Modification of Infrastructure Approval

Infrastructure Approval: SSI 9208 granted by the Minister for Planning and Public

For the following: Snowy 2.0 Exploratory Works

Modification: Tunnel boring machine and project layout refinements

Figure 1-1: Schedule of land and land ownership

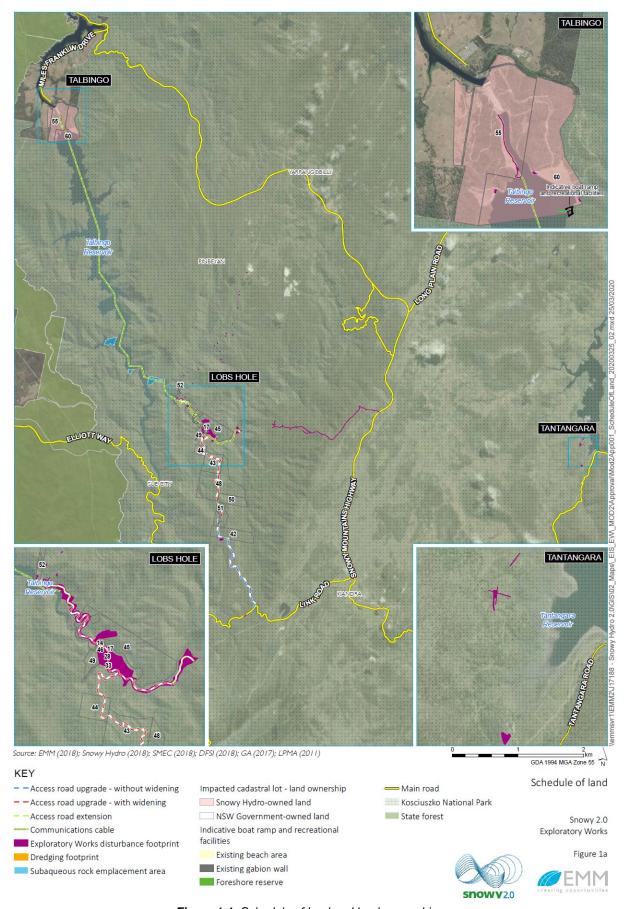
19. In Appendix 1, delete Figures 1-1 and 1-2 and replace with the following:

Figure 2-13: Project boundary – Lobs Hole Ravine Road north (1)

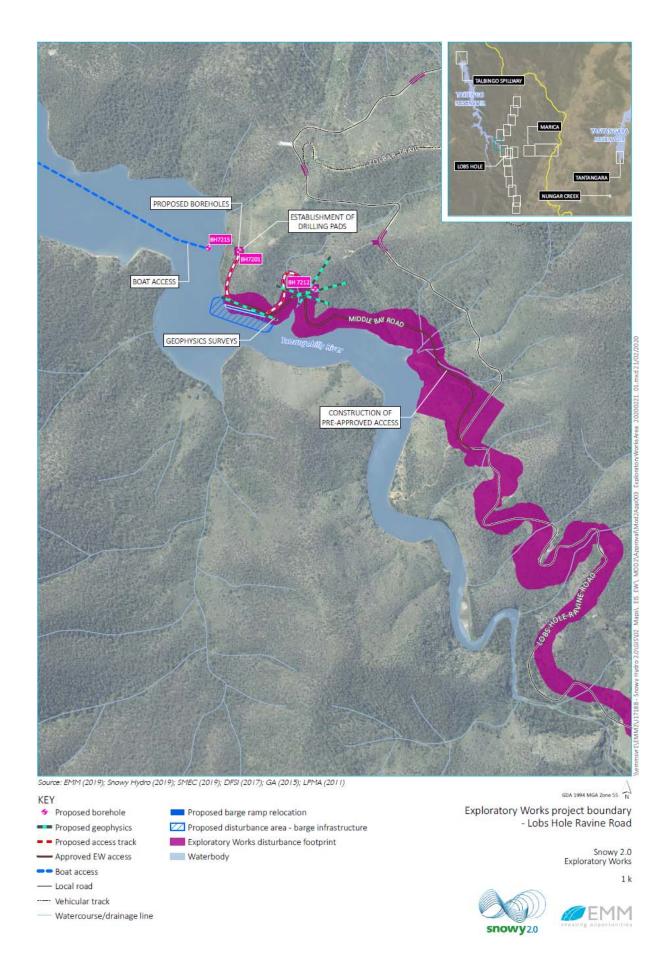
Lobs Hole Ravine Road - North

- 40A. Prior to using Lobs Hole Ravine Road North, unless the Planning Secretary agrees with otherwise, the Proponent must:
 - (a) upgrade Lobs Hole Road North in accordance with the approved plans (see the figures in Appendix 2) to the satisfaction of NPWS; and
 - (b) seal the last 30 metres of the road before its intersection with the Snowy Mountains Highway to the satisfaction of the TfNSW.
- 40B. Once Lobs Hole Ravine Road North has been upgraded in accordance with Condition 40A above, the Proponent must restrict the use of the road by the development to:
 - · access to and egress from the site during emergencies; and
 - light vehicles at all other times with:
 a maximum of 120 vehicle movements a day (60 each way); and
 an annual average maximum of 60 vehicle movements a day (30 each way).
- 12. Following condition 41 of Schedule 3, insert the following:

2-24: Road Upgrades Sharp Street/Bombala Street and Sharp Street/Vale Street Roundabouts

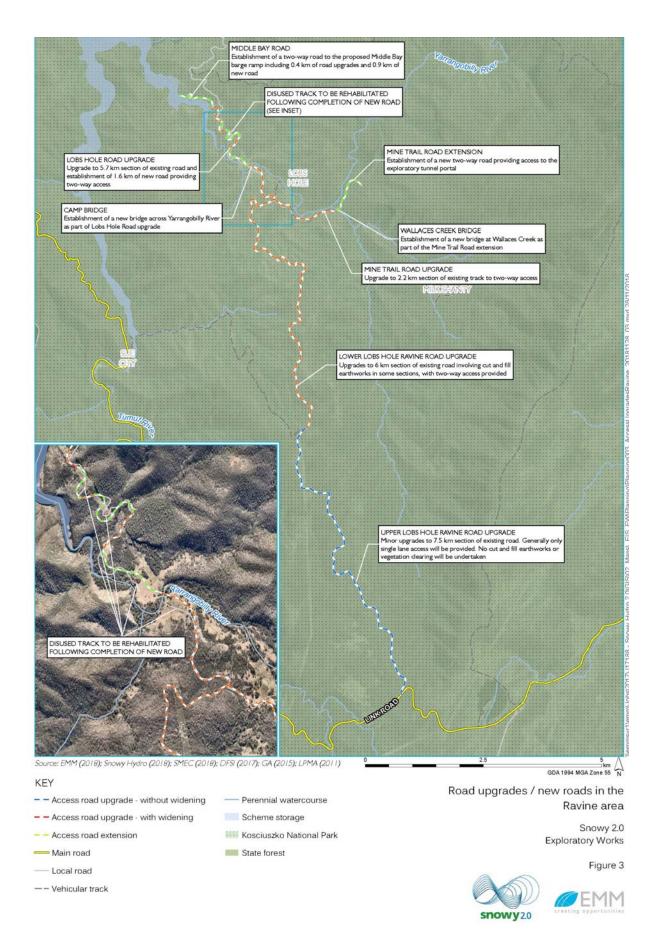
Sharp Street Roundabouts

- 42. Prior to using any OSOM vehicles to deliver the tunnel boring machine or concrete segments required to line the exploratory tunnel to the site, the Proponent must:

- (a) prepare detailed designs for the upgrade of the following intersections to the satisfaction of TfNSW and Snowy Monaro Regional Council:
 - Snowy Mountains Highway/Sharp Street and Bombala Street intersection; and

- Snowy Mountains Highway/Sharp Street and Vale Street intersection:
 - (b) ensure the designs comply with the relevant requirements in the Austroads Guide to Road Design (as amended by TfNSW supplements), and include works to the existing kerbs, signage and internal roundabout pavement to accommodate OSOM vehicle movements; and

- (c) carry out the approved upgrades to the satisfaction of TfNSW.
- 13. In condition 43 of Schedule 3:
 - i. in point (b), insert "and" after "Ravine campground;"
